PRELIMINARY TOLL SITING TECHNICAL MEMORANDUM

I-95/State Road (SR) 9 Project Development and Environment (PD&E) Study

Financial Project:	414964-1-52-01	Submittal Type:	OTHER
Submittal Phase:	PD&E	Submittal Staff Type:	CONSULTANT
Received Date:	12/30/2024	Response Due Date:	1/24/2025
Grace Period:	0	District:	SIXTH
Status:	OPEN	Create Date:	12/30/2024
Create User Id:	RD652JG	Last Update:	12/30/2024
		Last Update User Id:	RD652JG

414964-1:Draft Toll Siting Technical Memorandum.
Group: PD & E
Phase Review Type: Other Reports
Status: Submitted
Phase Initiation Date:12/30/2024
Comments Due Date:1/17/2025
Days Allowed for Review:19
Review Meeting: 1/23/2025 1:00 PM to 1:30 PM @ TEAMS
Plans Received Date:12/26/2024
Plans Format: Electronic
Comments: Draft Toll Siting Technical Memorandum
TEAMS Link -->
https://teams.microsoft.com/l/meetup-join/19%3ameeting_MGM2NjBhNGEtNGM2Zi00NzYwLWE0NDgtMTM3MTM1MTNiZDIk%40thread.v2/0?context=%7b%22Tid%22%3a%22db21de5d-bc9c-420c-8f3f-8f08f85b5ada%22%2c%22Oid%22%3a%2297a07b94-7b49-4909-a65b-3e37bc0b88ce%22%7d

SHEET NO.
9

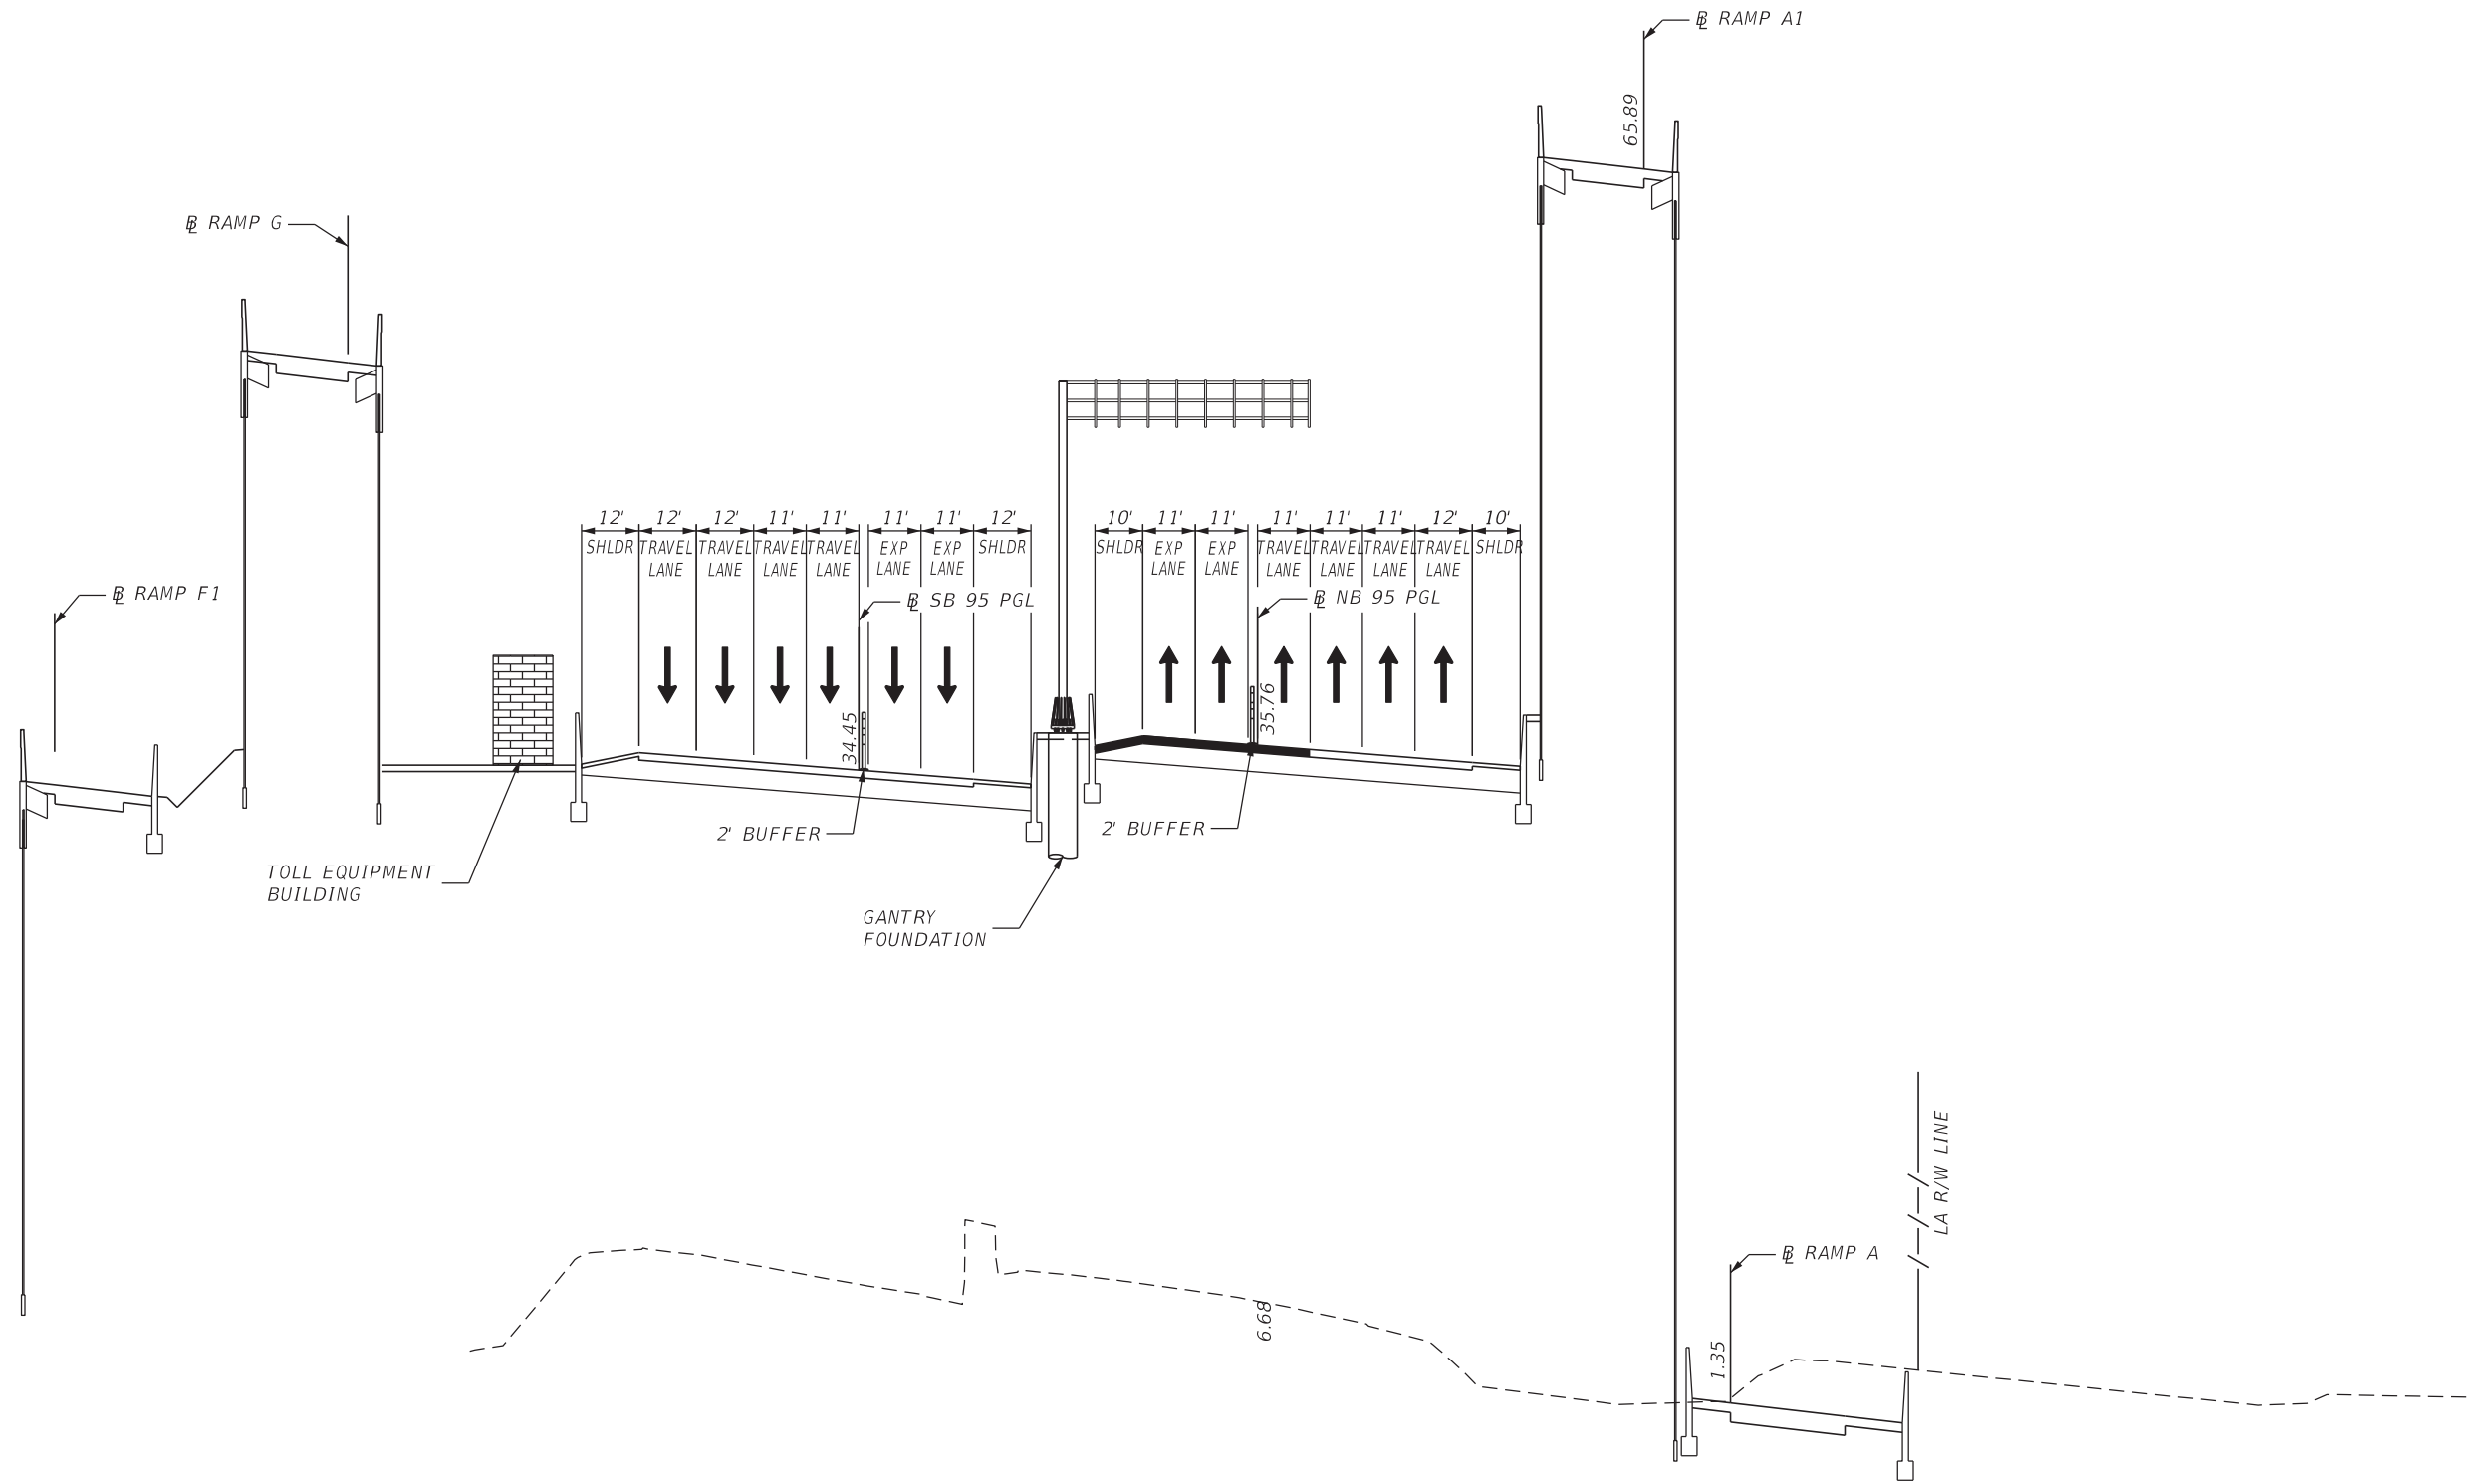
No	Status	Current Holder	Reference	Categories
5	COMMENT AGREED WITH		DRAFT TSTM - Toll Site 2N	TOLLS
	Created By	Created On	Version	Delegate For
	Marline Daceus Hardaway	1/16/2025	1	
	Sheet 9, Page 12 of 29 Verify potential power routing as it appears that the routing shown interferes with bridge substructure. Coordinate with Roadway Lighting and ITS for shared utility corridors.			
	Jenn King	1/23/2025	1	
	Power routing shown is graphical in nature only but will be adjusted to avoid bridge substructure.			
	Jenn King	1/23/2025	1	
	Agree. Power routing shown is graphical in nature only but will be adjusted to avoid bridge substructure.

REVISIONS					STATE OF FLORIDA DEPARTMENT OF TRANSPORTATION			TYPICAL SECTION 2 NORTH (NTS)	SHEET NO.
DATE	DESCRIPTION	DATE	DESCRIPTION		ROAD NO.	COUNTY	FINANCIAL PROJECT ID		
					I-95	MIAMI-DADE BROWARD	414964-1-22-01

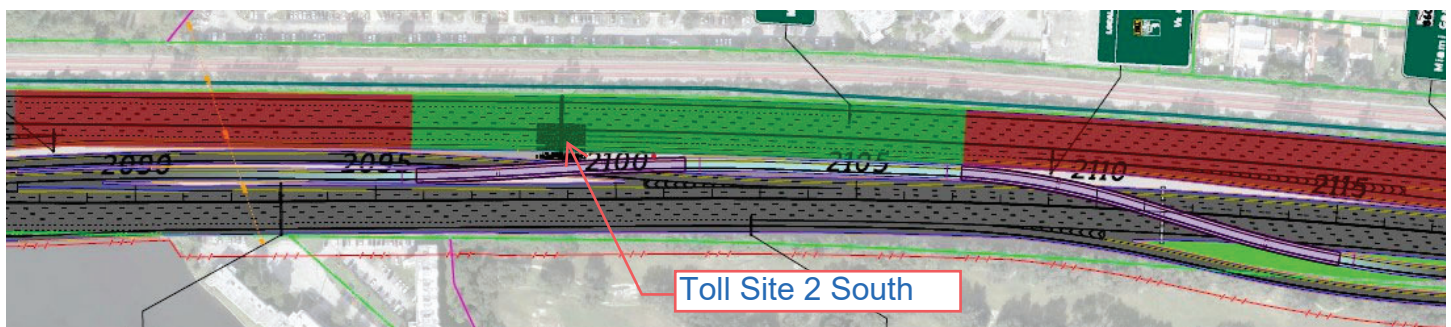
No	Status	Current Holder	Reference	Categories
8	RESPONSE ACCEPTED		Page 16 of 54	TOLLS
	Created By	Created On	Version	Delegate For
	Marline Daceus Hardaway	4/3/2025	1	
	Please show the Toll Equipment Building (TEB) on the Toll Site 2 North typical.			
	Jenn King	4/11/2025	1

The TEB will be added to the typical section.

REVISIONS				STATE OF FLORIDA DEPARTMENT OF TRANSPORTATION	TYPICAL SECTION 3 NORTH DATA (NTS)		SHEET NO.
DATE	DESCRIPTION	DATE	DESCRIPTION				
				ROAD NO.	COUNTY	FINANCIAL PROJECT ID	
				I-95	MIAMI-DADE BROWARD	414964-1-22-01

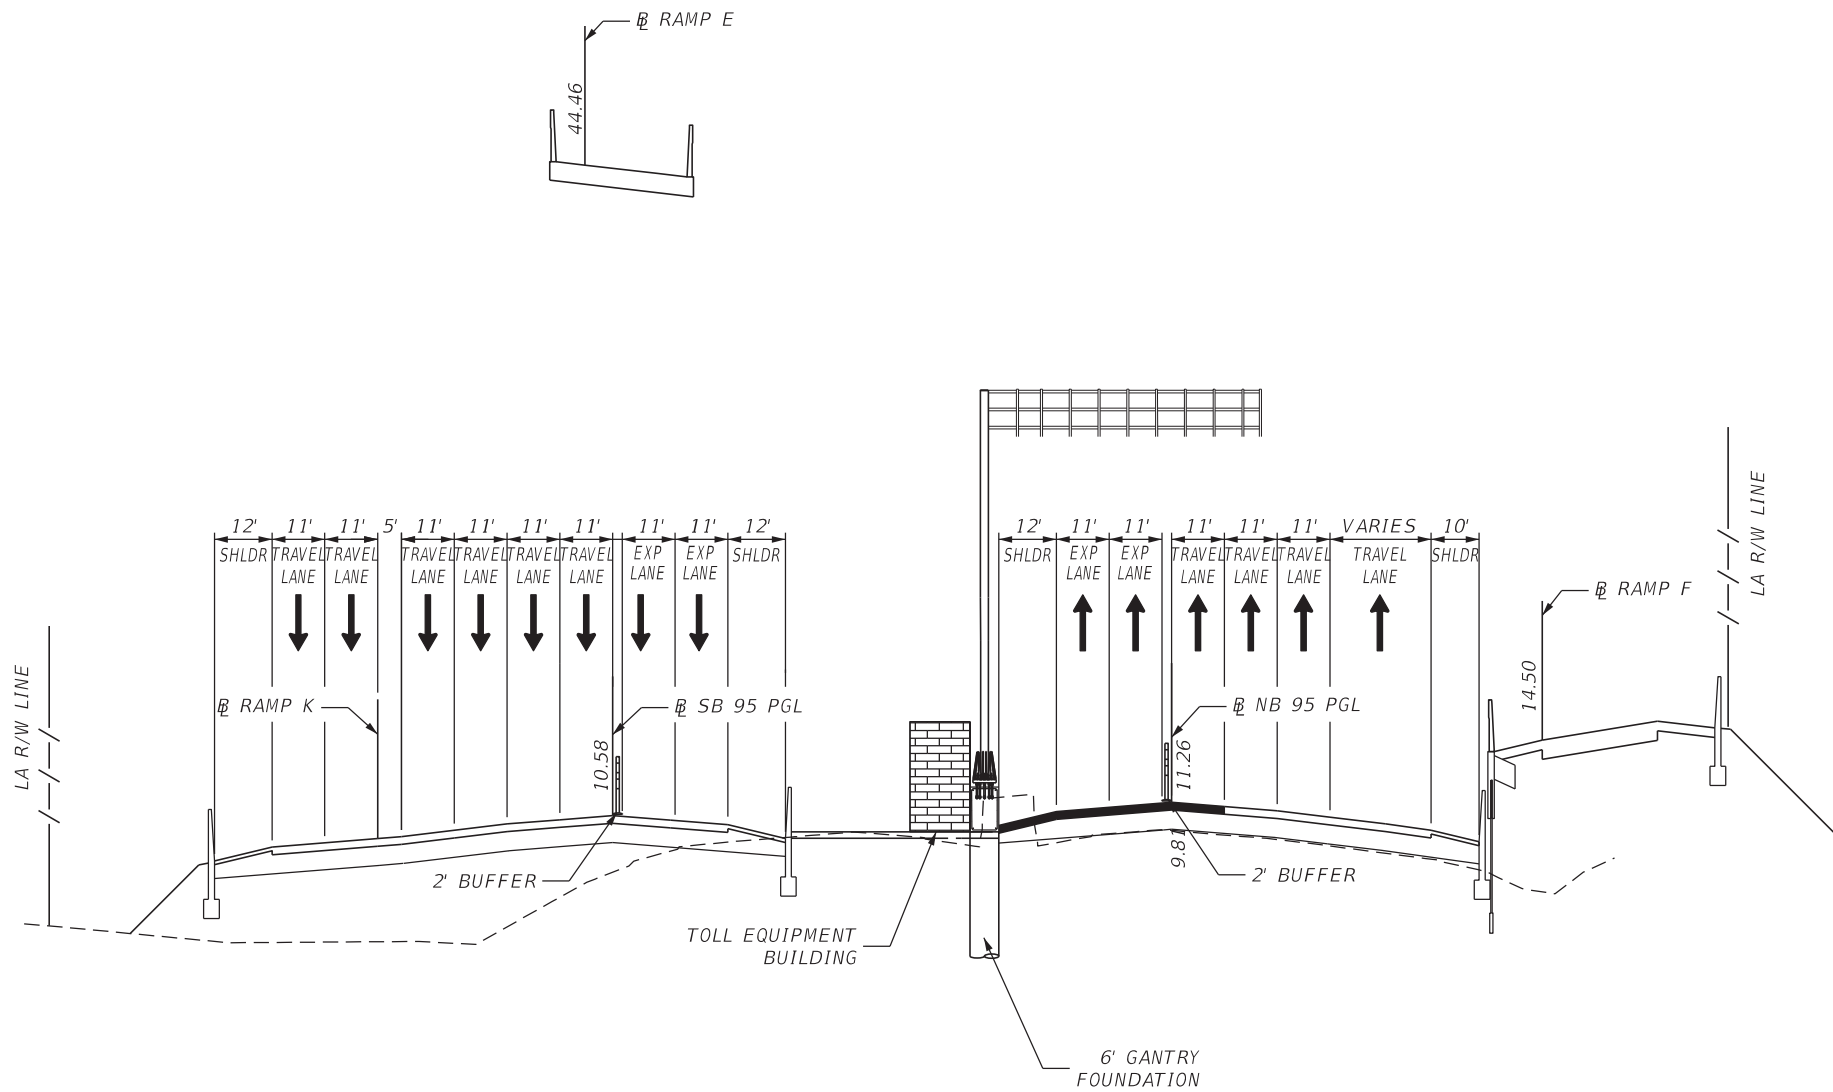
No	Status	Current Holder	Reference	Categories
12	RESPONSE ACCEPTED		Page 26 of 54	TOLLS
	Created By	Created On	Version	Delegate For
	Marline Daceus Hardaway	4/3/2025	1	
	Please show the TEB on the Toll Site 3 North Data typical.			
	Jenn King	4/11/2025	1	
	The TEB will be added to the typical section.			
	Marline Daceus Hardaway	4/23/2025	1	
	Response Accepted & Comment Closed

SHEET NO.
28A

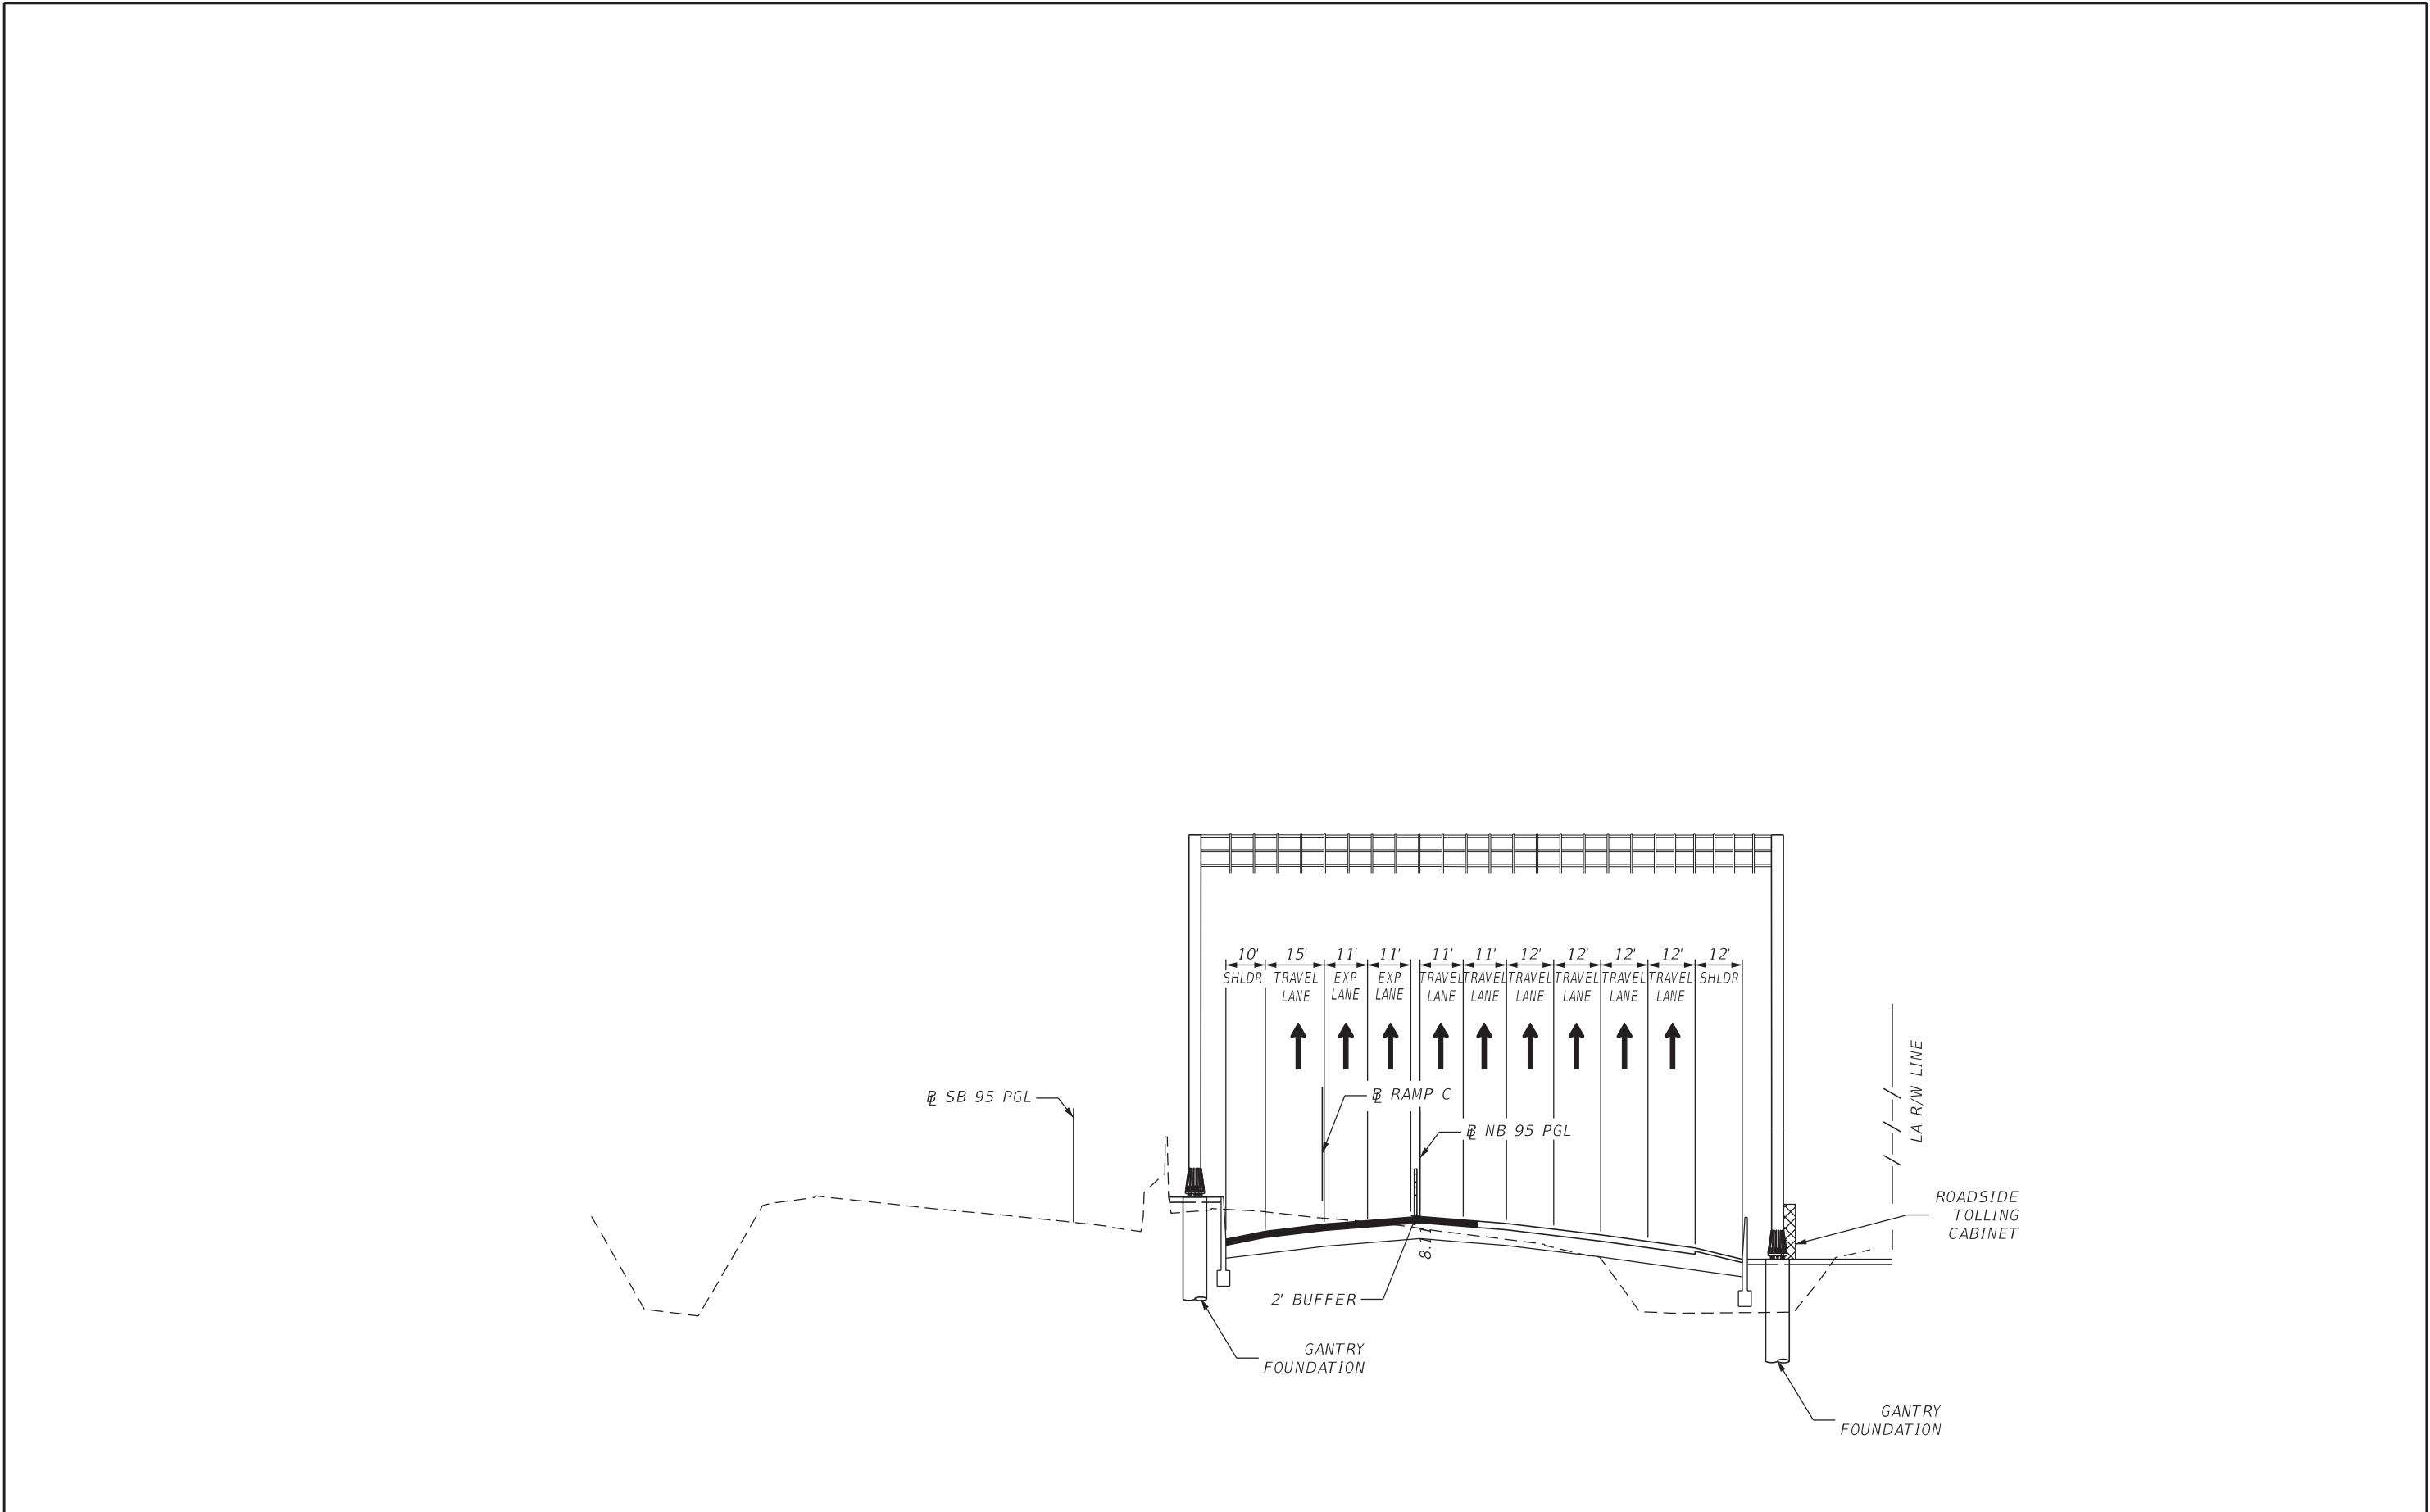
Sheet 28A, Page 24 of 29 Please verify the power service is within the district's jurisdictional limits. Also confirm there is a power service point closer than the xx miles provided.			
	Jenn King	2/11/2025	1	
	The power service identified is approximately 1,290 feet to the south of the proposed Toll Site 3 N location – essentially at the Miami-Dade/Broward County border. Although located in Broward County, Toll Site 3N will be part of the D6 project.			
	Marline Daceus Hardaway	2/12/2025	1	
	Please verify there is a closer power point presence that would be less than a quarter mile away. Please include contact name and phone number for each utility service provider.			
	Jenn King	3/11/2025	1	
	All power within the PD&E corridor is FPL. The service point identified appears to be the closest point to 3 North Toll where power crosses the corridor. For the PTSTM during the PD&E Phase, we are only identifying a potential electrical service point and not identifying or coordinating an actual service point. Further identification and coordination of a power service point will occur during Final Design.
